# Historical Architectural Review Board

## COA Final Review Sheet

**Address: 322 N. 8th Street**

**Proposal: Construct rear garage**

**N. Lumber Street side of proposed garage per manufacturer website.  
(Applicant)**

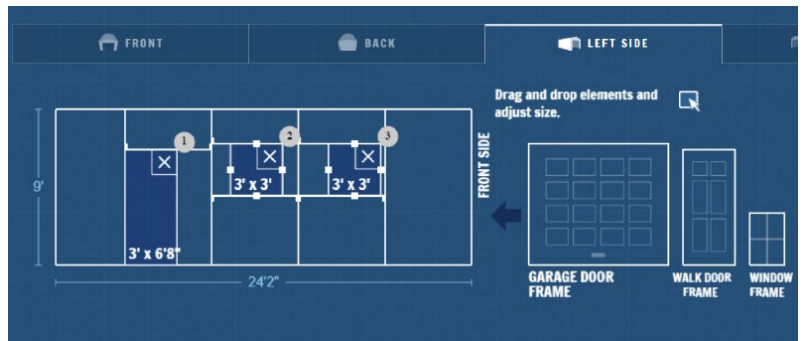
While the application lacks a site plan and details on the windows and doors, the general materials of the proposed garage are not appropriate for the district and do not comply with Guideline 5.2.10. More appropriate materials, such as brick or wood, should be considered for the structural elements and cladding, as noted in Guideline 5.2.9. Windows and doors should be wood or aluminum clad wood. The general panel configuration of the garage door and pedestrian door are acceptable. The windows should be one-over-one double-hung sash windows to more closely relate to the proportions of the main building, as recommended in Guideline 5.2.8.

The general size, scale, and massing of the building satisfies the guidelines, since the proposed structure would be subordinate to the main building. A site plan should confirm that the building would be constructed to the rear property line with no setback to satisfy Guideline 5.2.7.

Denial, pursuant to Chapter 5, Section 5.2 New Accessory Buildings, with the comment that more appropriate materials and proportions should be considered.
